UNITED STATES PATENT AND TRADEMARK OFFICE

APPLICATION NO.	FILING DATE	FIRST NAMED INVENTOR	ATTORNEY DOCKET NO.	CONFIRMATION NO.
09/933,169	08/21/2001	Larry A. Druga	114302.1721	6443

Office Action Summary

DETAILED ACTION

FIG. 2

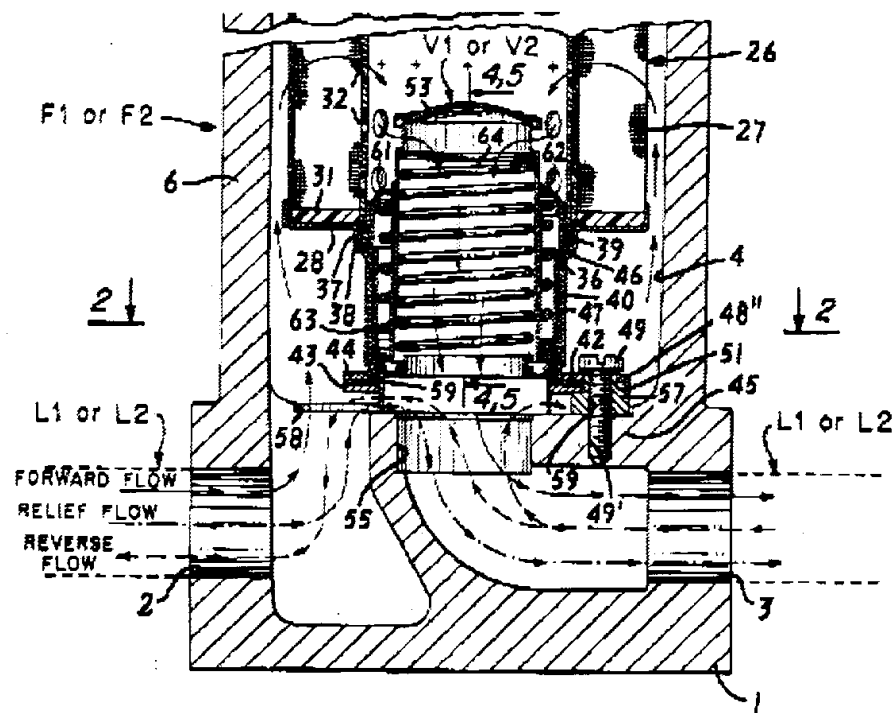
10. Claims 3 and 4 are rejected under 35 U.S.C. 102(b) as being anticipated by Cooper (U.S. 3,996,137). Cooper discloses a fluid filter that clearly anticipates claims 3 and 4. The bottom of figure 2 thereof is reproduced below.

The first, second, third fluid flows and the arrows thereof are shown above as the forward flow, relief flow, and reverse flow, respectively [as in claim 3], wherein the first flow path includes the

inlet 2, the space between the filter element 27 and the housing 6, the filter element, a central passage 35, and the outlet 3 [as in claim 4].

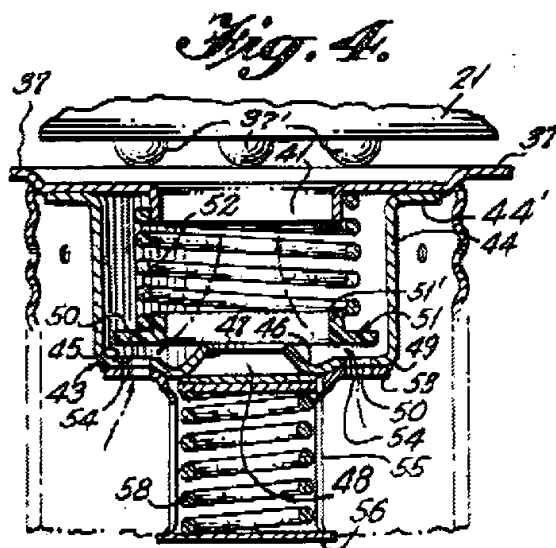
11. Claims 1-9, 11-12 and 15-17 are rejected under 35 U.S.C. 102(b) as being anticipated by Hultgren (U.S. 3,000,506). As shown in figure 4 reproduced below, Hultgren clearly anticipates claim 1.

As shown above, Hultgren discloses a first retainer 44 (or alternately 37 and attached wall 34), a first spring, a first disk 51, a second retainer 55, a second spring, and a second disk 57 (see figure 2), wherein the disks are operative to compress in opposite directions toward their respective retainers [as in claim 1].

As shown in figure 4, Hultgren also discloses the reverse flow bypass means to include a first disk 51 against a plurality of peripheral holes 50 in the end cap 45 operable to open toward the first retainer means (37) for fluid to bypass the media [as in claim 6].
